Name: Horizon Park East - Final Plan & Plat

FILE: 2-93 (2)
DATE: June 18, 1993
STAFF: Kathy Portner
REQUEST: Horizon Park East--Final Plat and Plan and ROW Vacation
LOCATION: South of G Road, West of Horizon Drive
APPLICANT: Bob Bray and Wayne Beede

RESPONSE TO REVIEW COMMENTS

TITLE HEADING: Change in Approved Golf Cart
Easement - Horizon Park East

HYDROLOGY
MAP

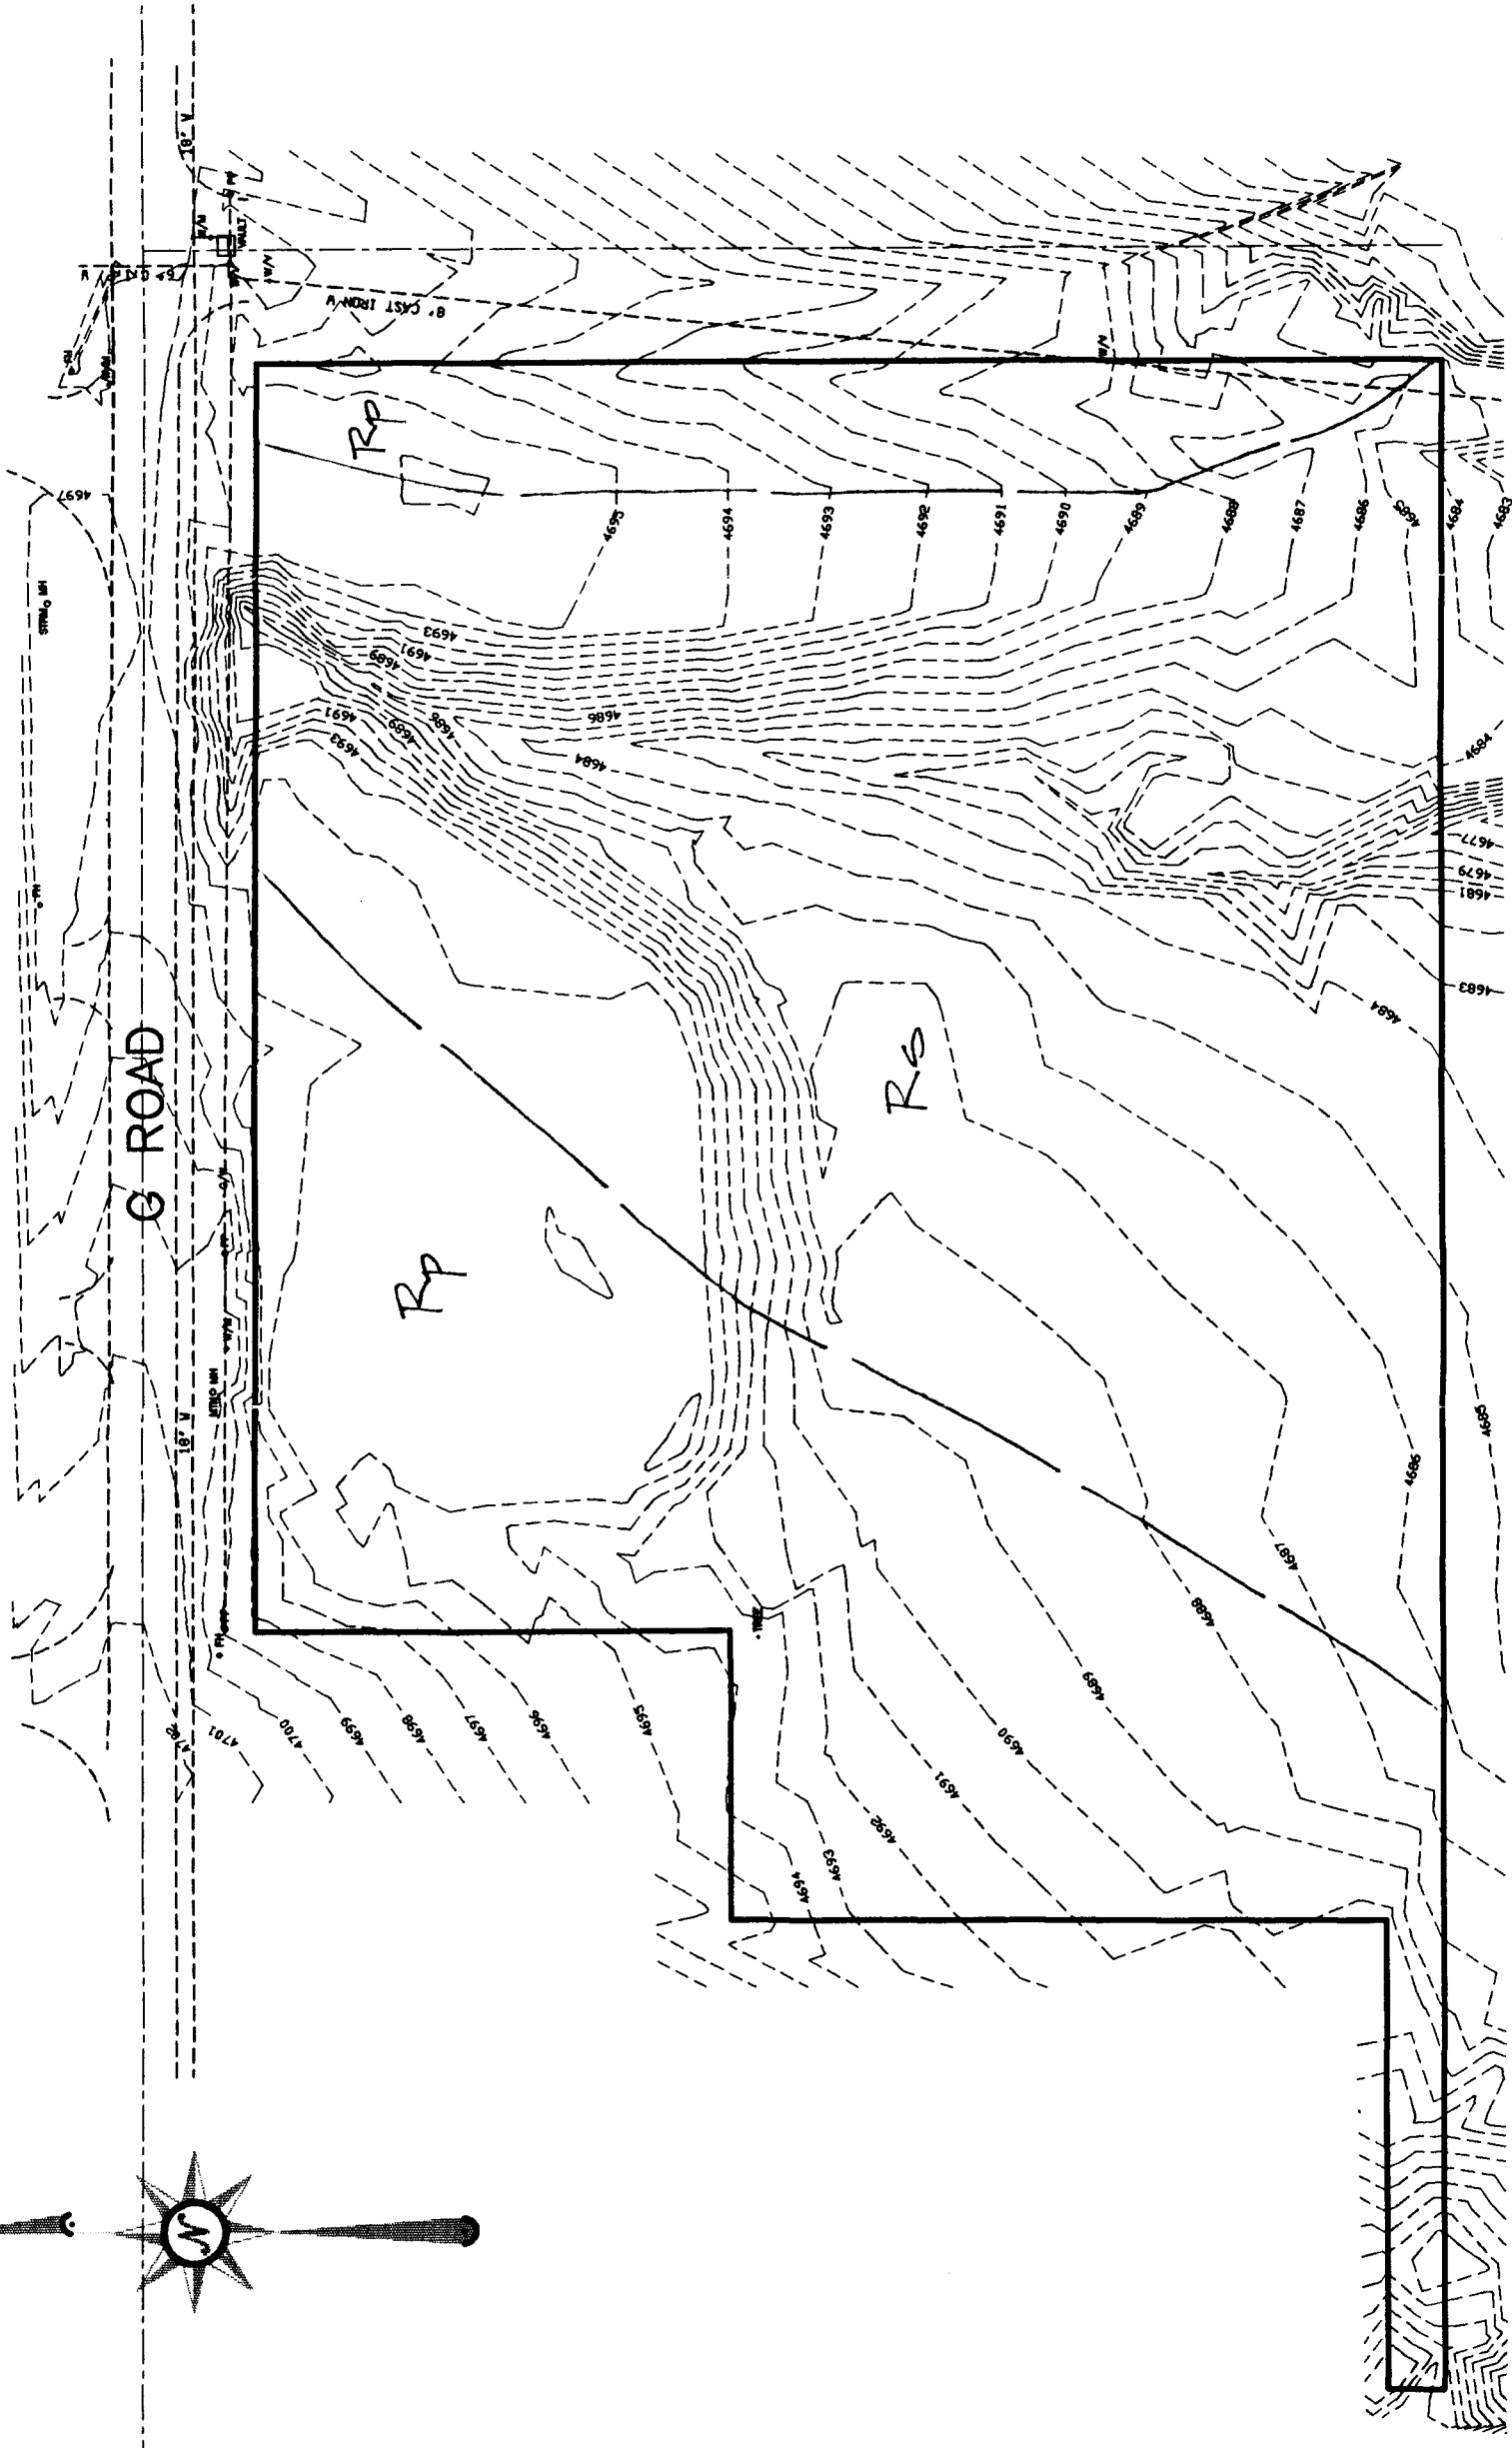
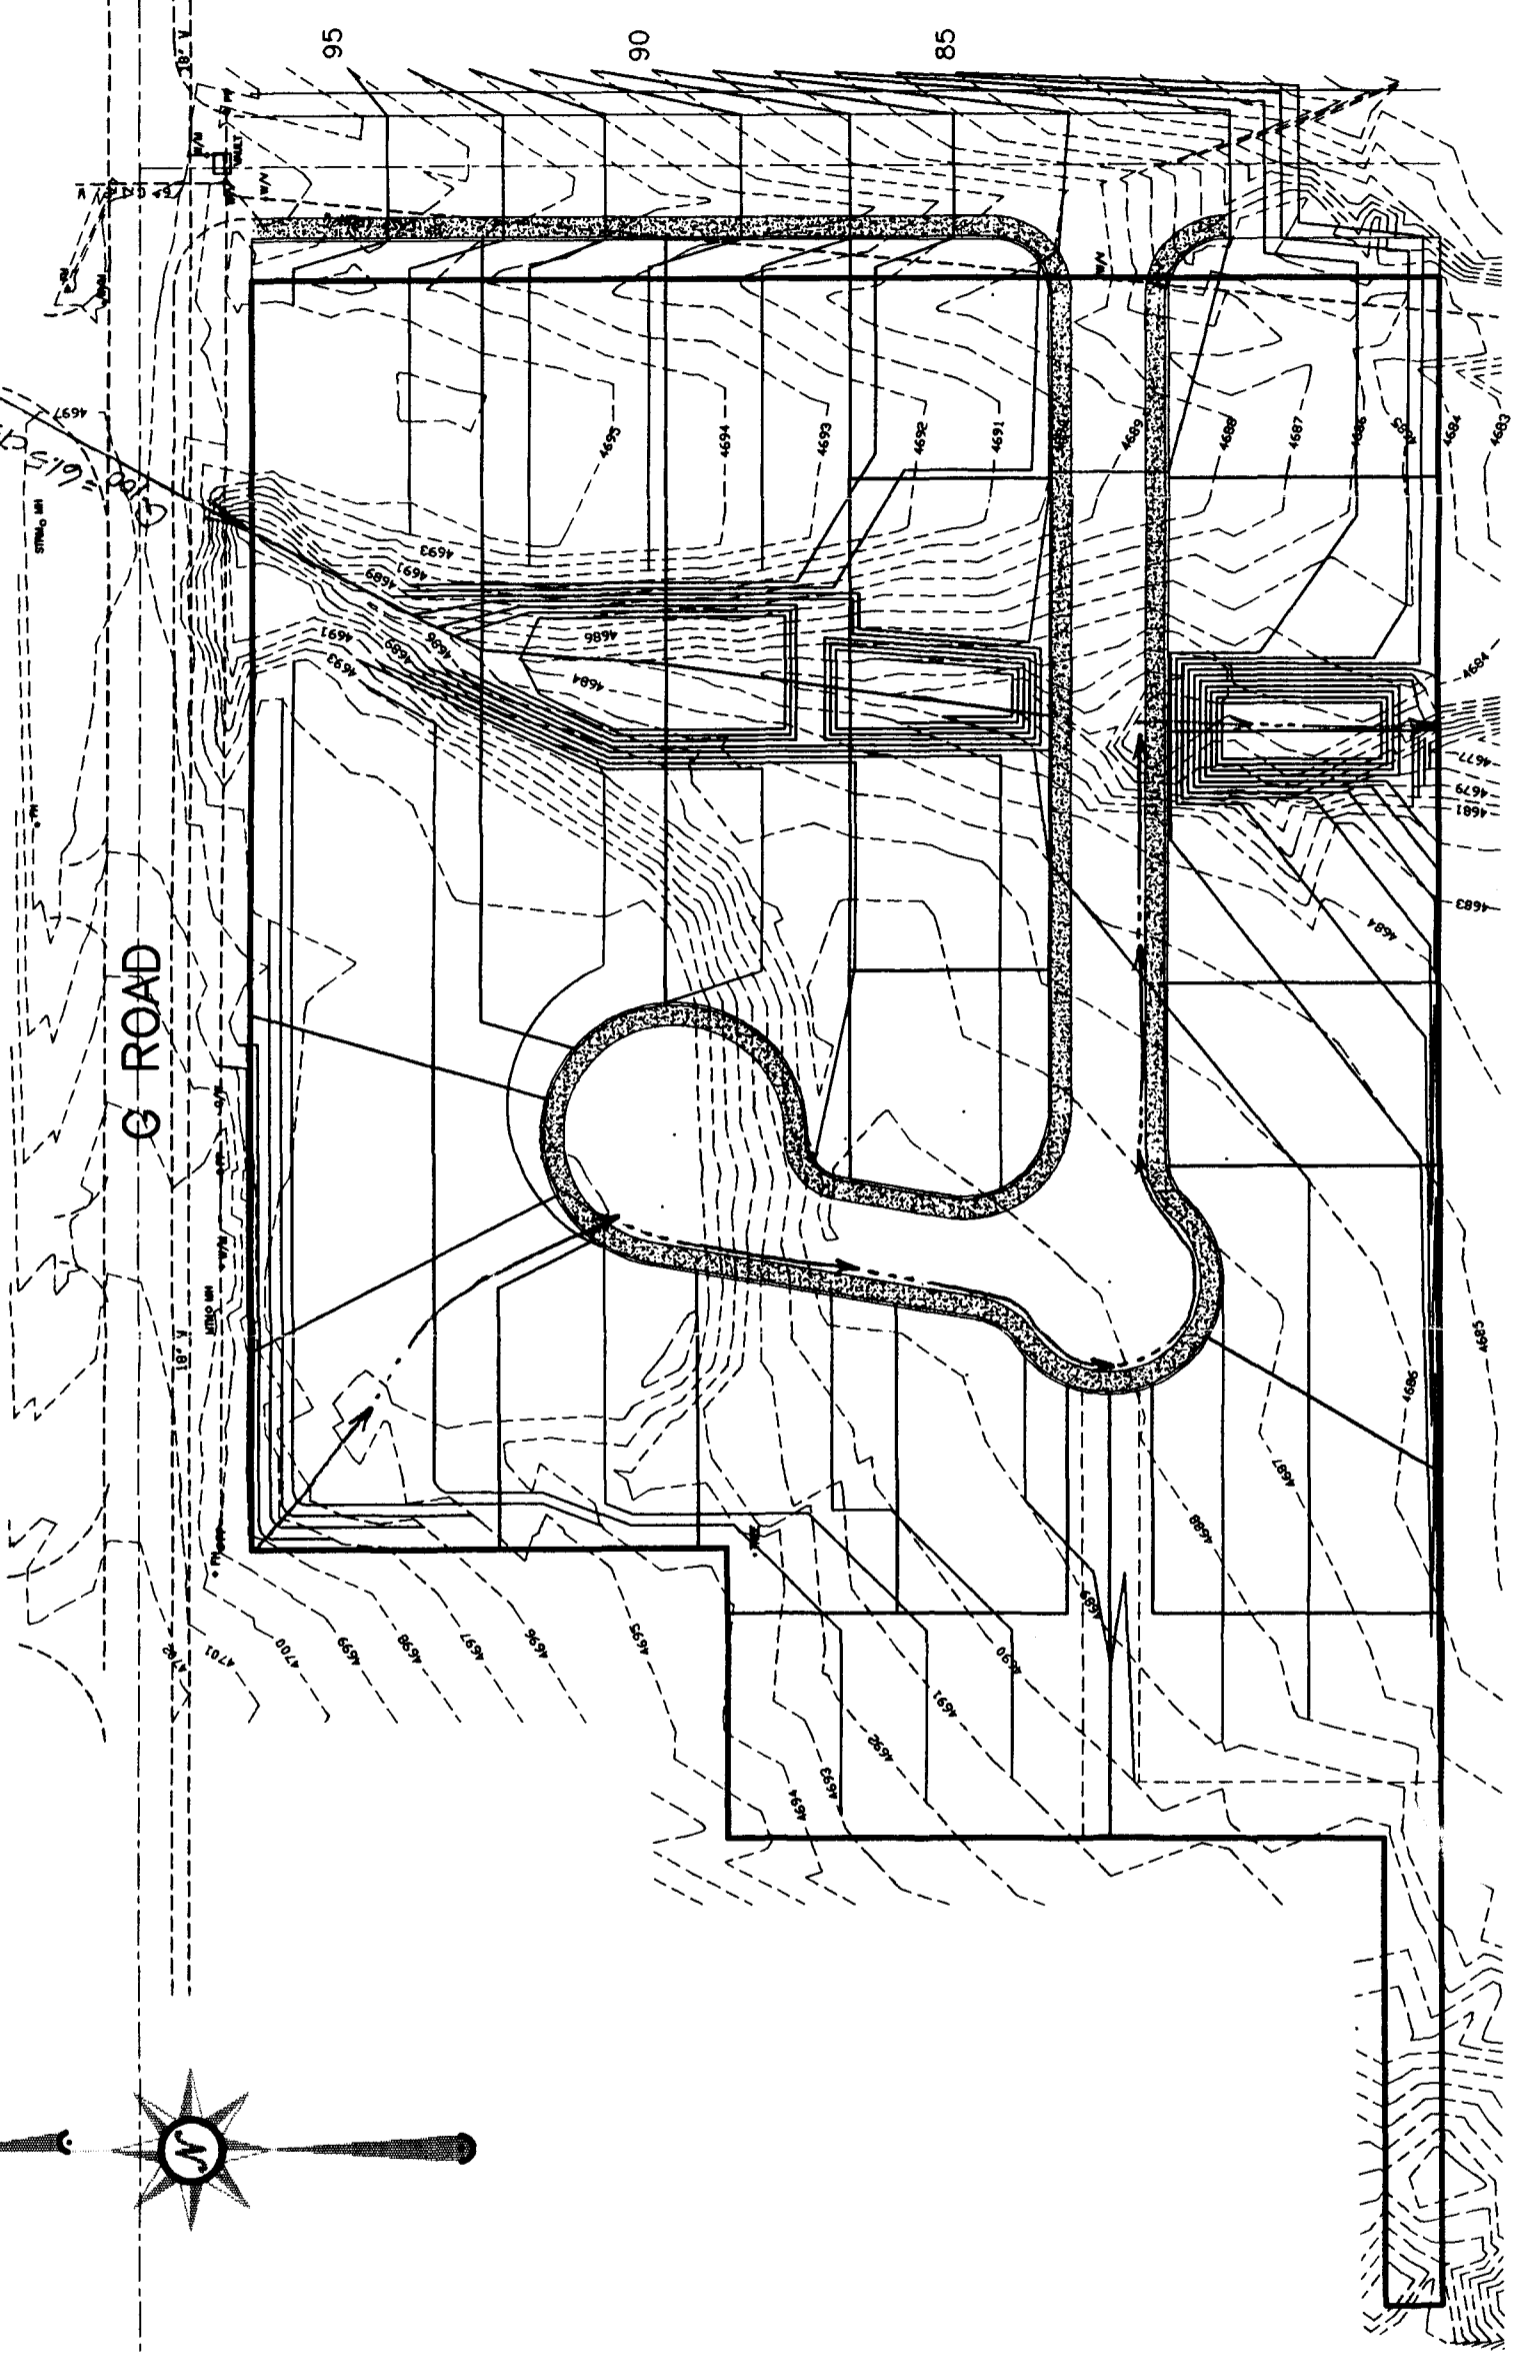
2. Outflows from the site may not exceed either the 2 year or 100 year historic storm; therefore, both storms must be analyzed.
3. The T_c values are not supported. Provide calculations.

4. Analysis with pre-and post-development 5.0 acres alone does not address site conditions, existing or proposed.
5. The detention basin does not have an outlet, yet calculations provide for one of orifice type.

Site Plan					
Horizon Park Joint Ventures					
LANDesign					
<small>ENGINEERS • SURVEYORS • PLANNERS</small>					
<small>259 GRAND AVENUE GRAND JUNCTION, COLORADO 81501 (970) 245-4099</small>					
PROJECT NO. 97045-40	DESIGNED	DRAWN	CHECKED	SHEET	OF
DATE: April 1997	CMB	CMB		1	1

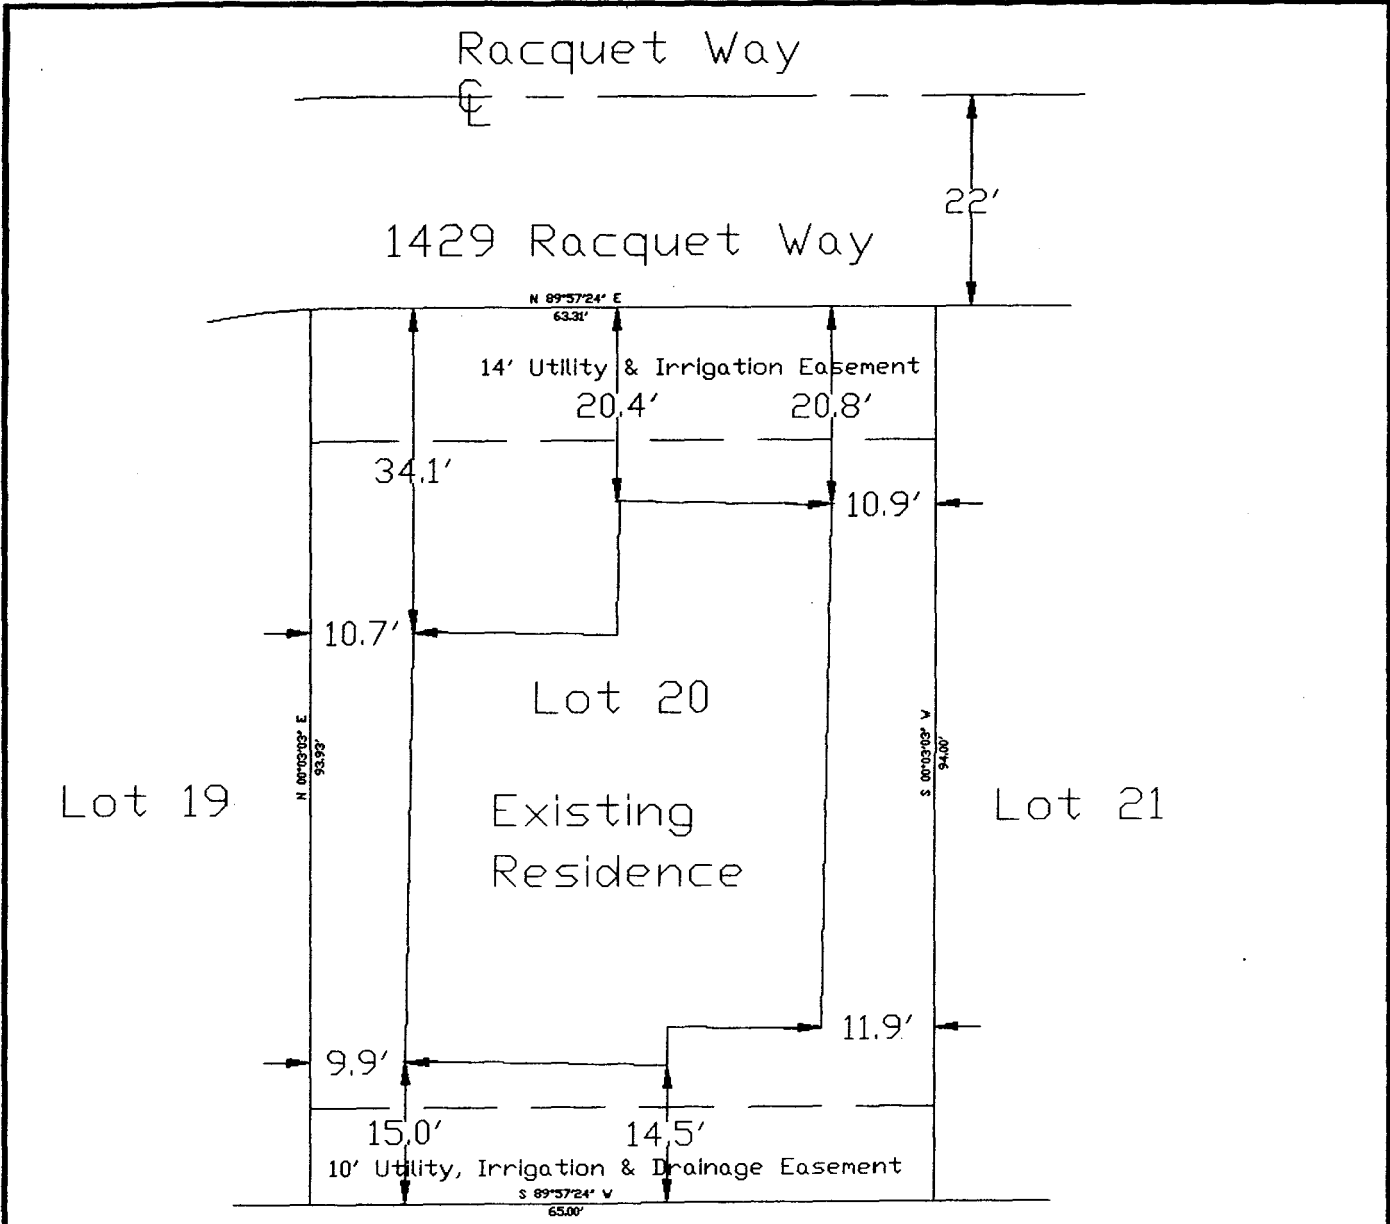
This is in response to your request for a minor amendment for lot 20, Horizon Park East Subdivision to allow a portion of the house to encroach 6" into the required rear yard setback. Based on section 7-5-6.A.2.d of the Zoning and Development Code, the request is approved. The 6" encroachment was a result of inaccurate lot dimensions being shown on a sales map and the decrease in the setback will not negatively affect adjacent properties. The property to the south is zone for business uses.

- Item 1. The sales map provided to our client shows Lots 20, 21, 22 & 23 to be 95 feet deep. The actual depth shown on the recorded plat are 94 feet. Our client designed the residence using the sales map dimensions.
- Item 2. The concrete contractor, CRM Concrete, did not check the offsets to the existing lot corners. They relied on the sales map provided by the owner. The contractor also used the existing stucco fence as the rear lot line. The rear lot line is actually inside of Lot 20 by 0.5 feet.
- Item 3. The residence has been completed and sold. When our client applied for a planning clearance for Lot 21, the error in the sales map was discovered. This led to the check of the existing residence located on Lot 20.
- Item 4. Our client has had several discussions with you and your staff as to resolution of the encroachment.
